Appendix B
Responses to Notice of Preparation

Please enter this letter as a public comment in response to the Town of Danville's Notice of Preparation/Initial Study for the Magee Ranches project.

The Diablo Community Service District and the Diablo Municipal Advisory Council are asking that the Town of Danville consider the following, in preparation for the upcoming Draft EIR for the "Magee Ranches" project:

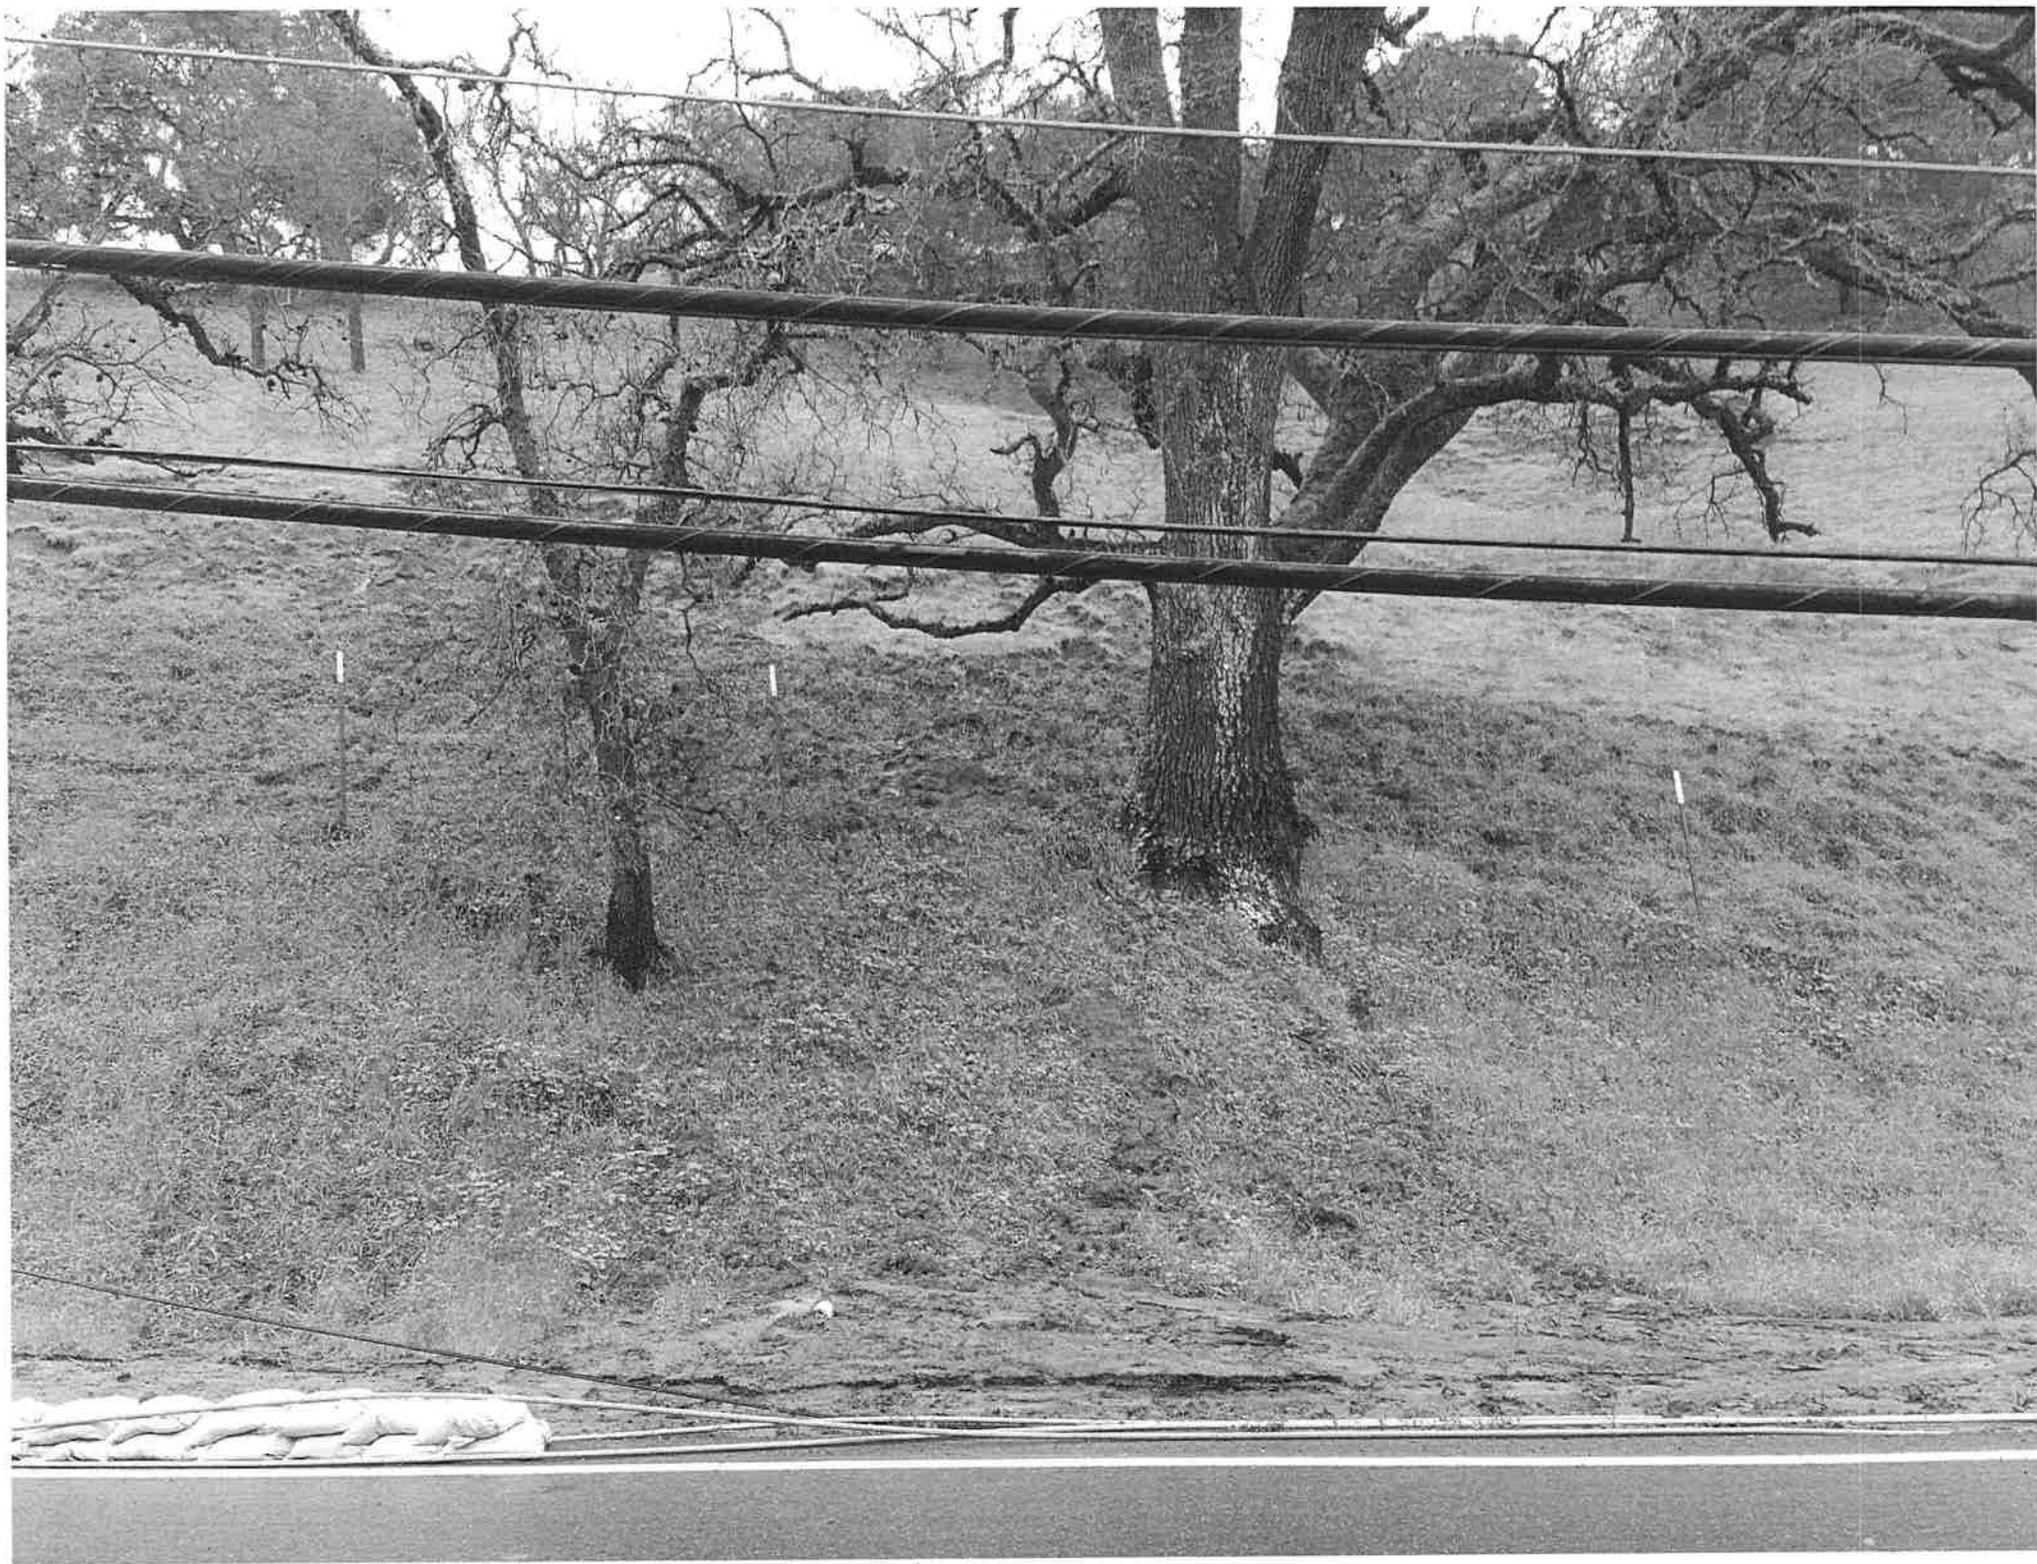
The draft EIR must include an analysis of **the need for repair and maintenance of the approximately one - mile stretch ("the stretch") of hillside adjacent to and south of Diablo Road between Alameda Diablo and Avenida Nueva.** Mudslides every winter (please see photos attached hereto and described below) render the road even more dangerous than it typically is the rest of the year. Mudslides routinely require the road to be closed for cleaning of the road, replacement of sandbags, and digging out of the mud piles adjacent to the road to make way for more mud.

In the NOP/IS, ENGEO was quoted as saying that "the conditions described in the 2013 EIR with respect to potential effects of landslides on the Project have not substantially changed."

That statement misses the important facts that the hillsides adjacent to Diablo Road are part of "the Project" and must be considered as part of any approval of the Project, and that those hillsides have been substantially changed by the rains last winter.

Figure 1 - Upper Green Valley Creek Watershed upstream of the Diablo Road/Alameda Diablo intersection.

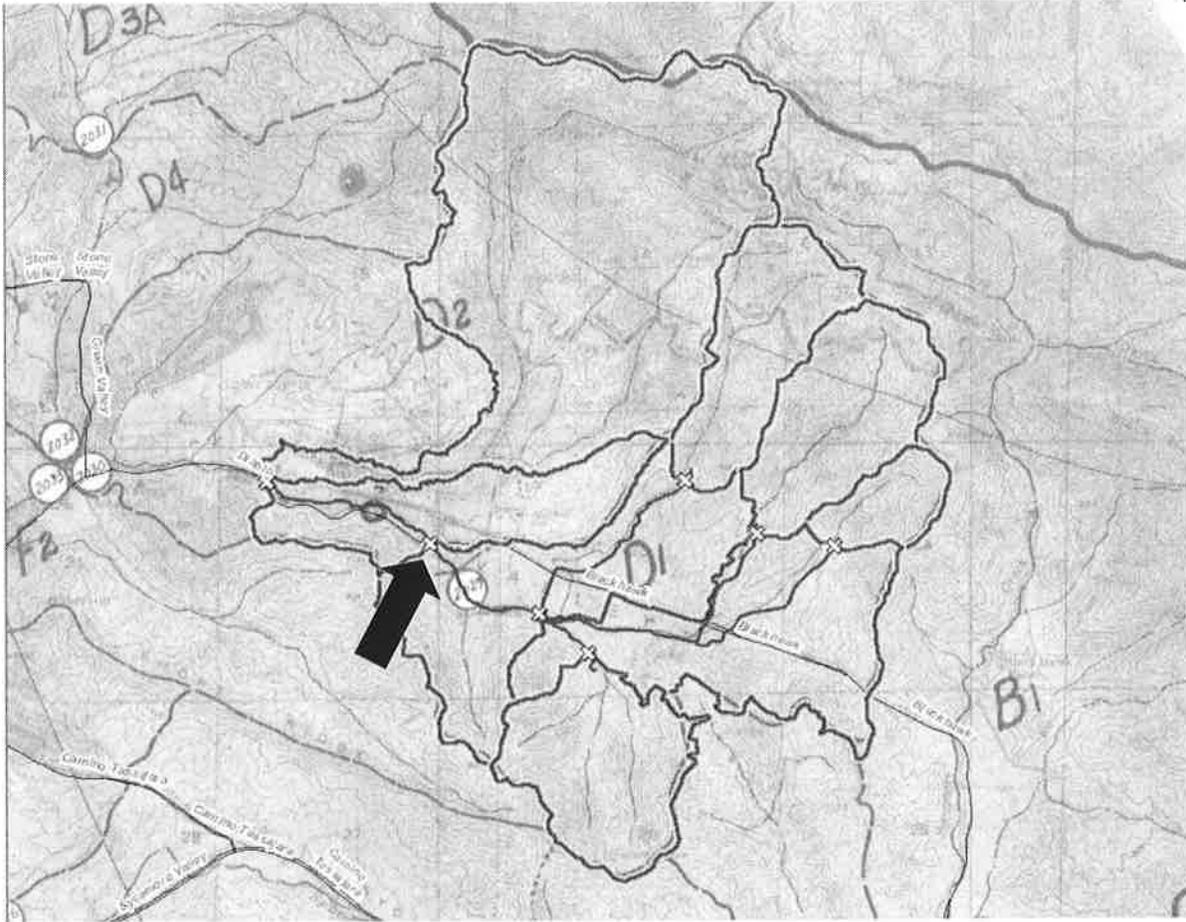
An image of the modeled watersheds is provided below. The point of interest for the private bridge is the “X” point on far east (left) of the watersheds that are outlined in green. The red lines on the image represent the main flow paths. The four “X” points at the upstream ends of the red lines are the locations of the four (4) existing detention basins.

Figure 2 - Watershed overlaid on the 1977 study hydrology map.

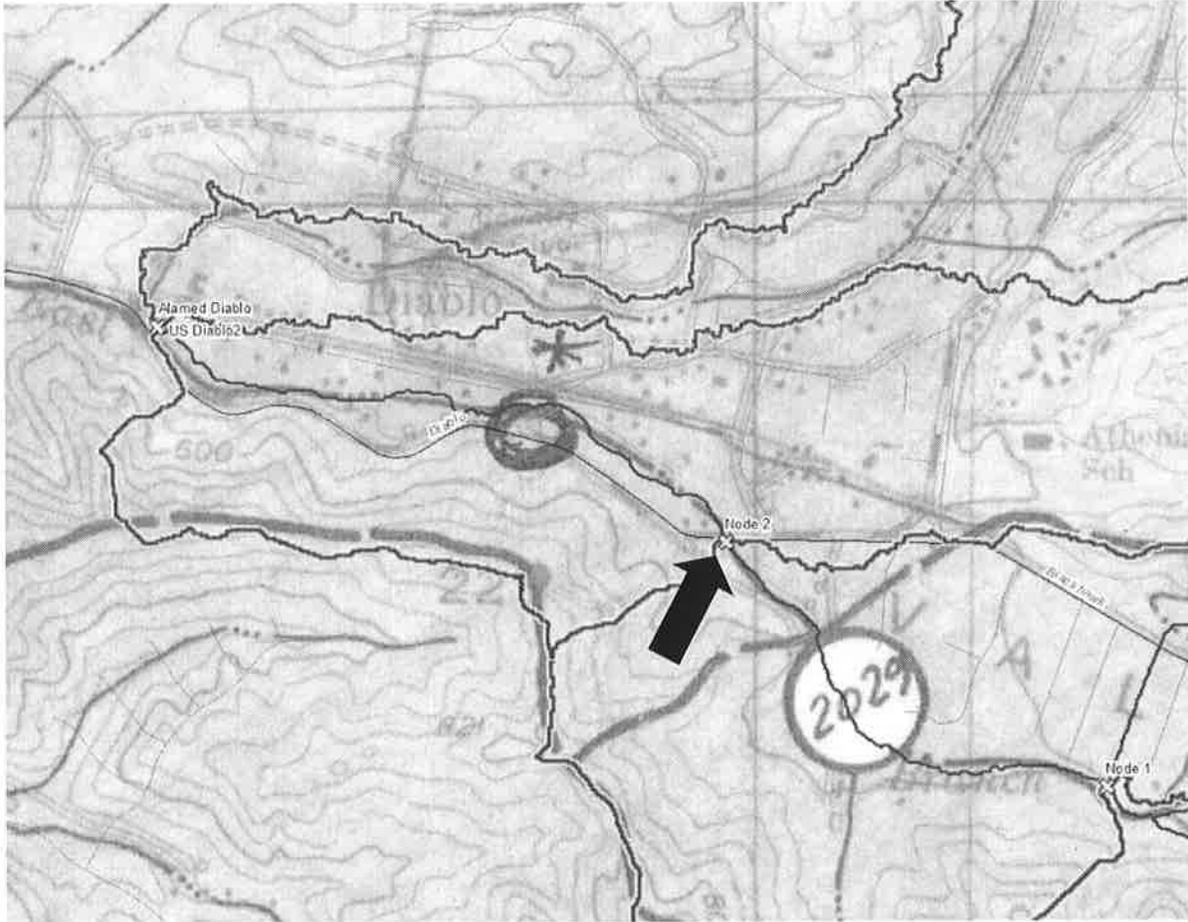
The next image is the same area overlaid on the hydrology map from the 1977 hydrology study. We can see two “points” on the old map, that are near the point of interest (the proposed pedestrian bridge). These are points 2029 and 2030. The 100-year 6-hour storm flow rates from the report for these points are shown in the table below.

Figure 4 – Plot of 100-year 6-hour flow rates from studies

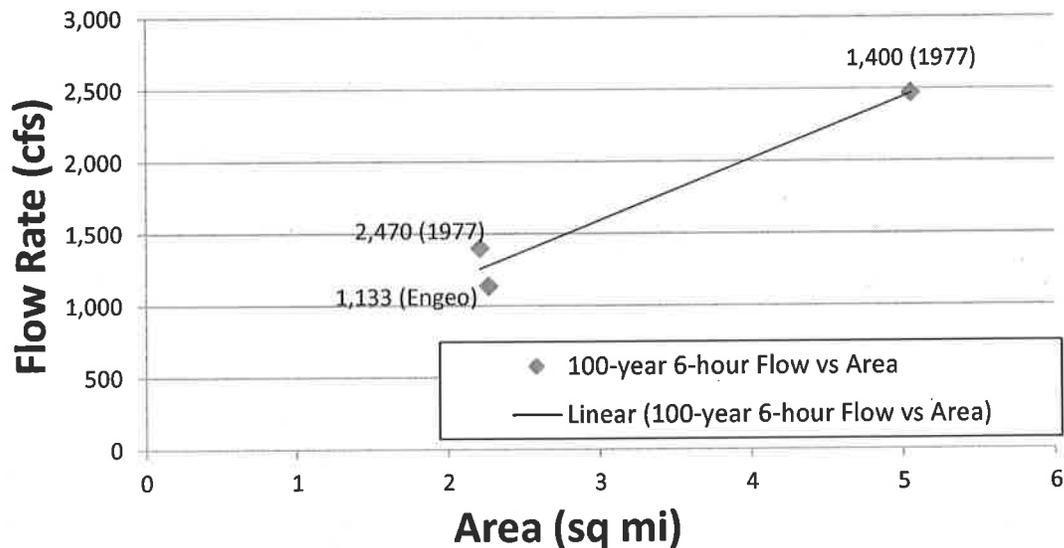
The 2011 hydrology study done by Engeo, Inc. for Magee Ranches produced a flow rate for the 100-year 6-hour storm of 1,133 cfs at the point labeled “Node 2” in the images above. This point is also marked by a black arrow in the images above. This is a crossing of Diablo Road over GVC upstream of the point of interest. For that point, the Engeo, Inc. report calculated 1,133 for the 100-year 6-hour storm and 1,558 cfs for the 100-year 24-hr storm. The Engeo, Inc. report had an area at that point of 2.268 square miles

Figure 5 – Plot of 100-year 6-hour flow rates from studies

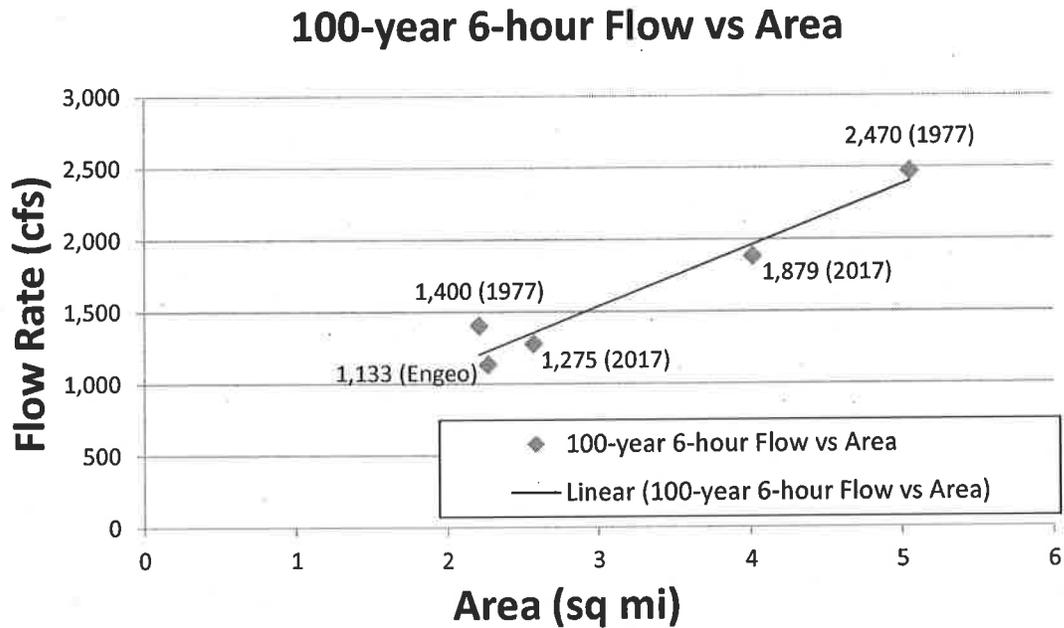
1. A draft hydrology study prepared by a Contra Costa County Flood Control engineer (attached below) indicates that the 100- year, six- hour storm would result in **1879 cubic feet per second ("cfs") peak flows at the culvert entrance**.
2. Danville's City Engineer Steve Lake stated in an April 24th email to Mr. Gary Rich, owner of 1700 Alameda Diablo, that the **12-foot- diameter culvert accommodates only 1700 cfs**.
3. The difference between the culvert's 1700 cfs capacity and the anticipated 1879 cfs flows in a very large storm shows that the culvert is 173 cfs too small. That means that the culvert **would back up and overflow at a rate of approximately 173 cfs for the duration of peak flow and at a lesser level before and after peak flow.**

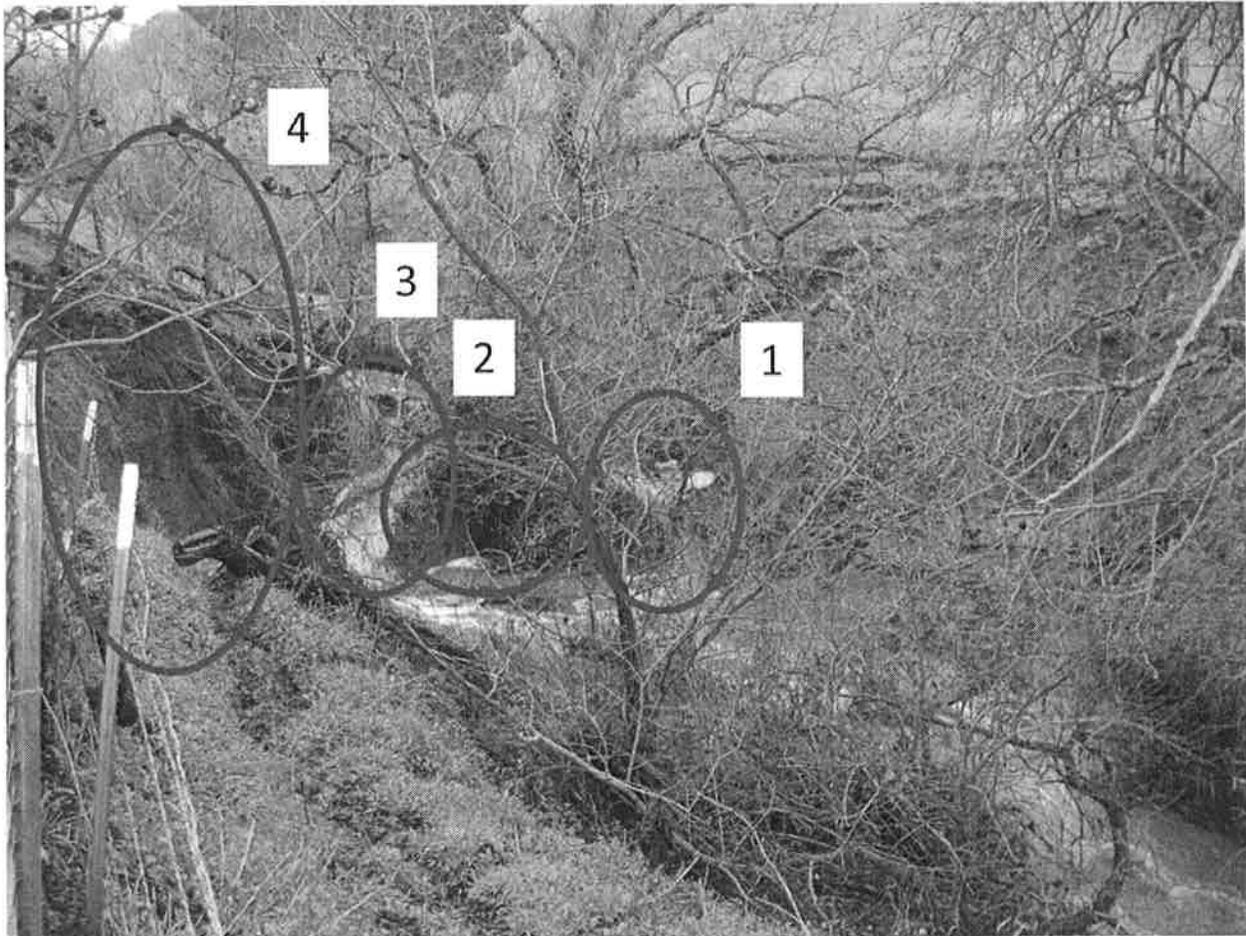
Severe erosion of the creek bank has occurred. This is most severe south of 49 Diablo Creek Place resulting in significant loss of property and the prospect of continued erosion due to the steep and unstable creek bank and sandy nature of the creek bed.

In this picture 1 denotes the historic channel; 2, the vegetation blocking the flow; 3, the new channel north of the vegetation; and 4, the severe erosion on the north bank of the creek. Note that the south bank has eroded as well.

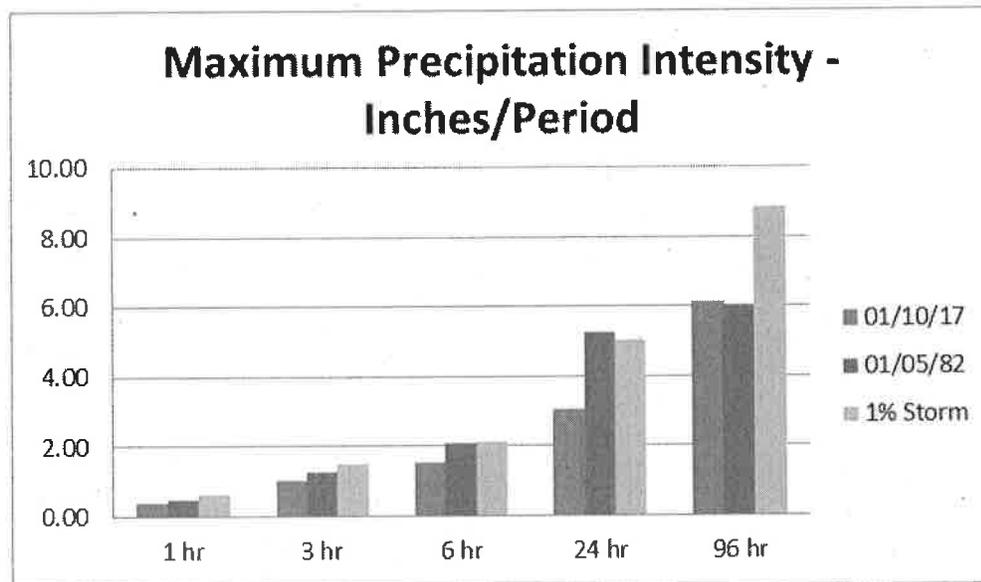
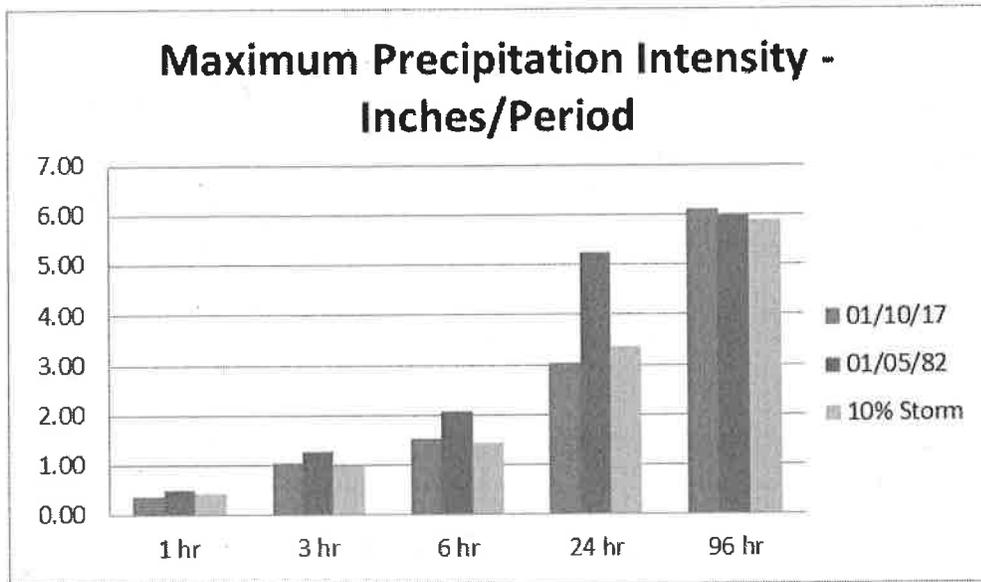
included in the charts below to put the intensity of the Jan 10th storm in perspective relative to a 1982 storm and the likelihood of such an event. (The 96 hr totals were projected by the Corp for the upper East Branch of Green Valley Creek, the shape of the storm was consistent with the modified 96-hour distribution pattern tabulated in Table 8C of the Corp's report.)

The Jan 10th storm compares closely with the characteristics of a 10% storm and is far less intense than the 1% storm as characterized in the Corp's 2008 report. The Jan 10, 2017 storm was less intense than the January 1982 storm over 24 hrs, but matched the 1982 rainfall total over a 4 day period.

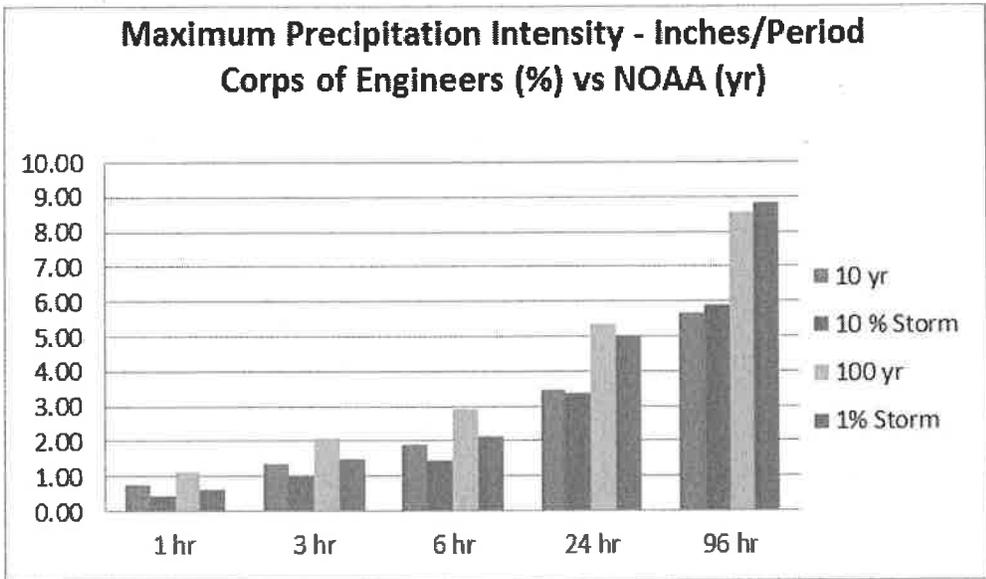
http://hdsc.nws.noaa.gov/hdsc/pfds/pfds_map_cont.html?bkmrk=ca . NOAA probabilities, , are compared to information presented in the Corp's 2008 report in the chart below:

NOAA probabilities indicate somewhat higher rainfall for periods 24 hrs and less and slightly lower rainfall for a 4 day event.
